Crowcon Technical Note

Document Reference: GEN061 - Control System Software

Subject: System operation in sensor over-range state

Document applies to: Gasmonitor manufactured before September 2008

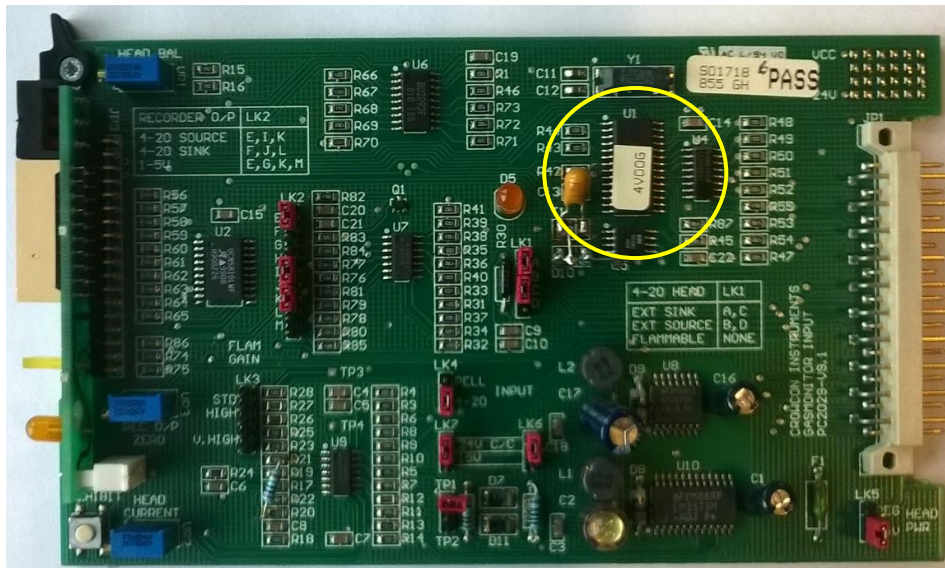
Input Module Software revisions affected	3V00G, 4V00G
--	--------------

The Gasmonitor software revision is identified by a label on the input module (see below).

If software upgrade is required, the input module must be replaced. If modules are replaced, the module and system configuration must be re-checked and the module must be re-calibrated along with the connected detector.
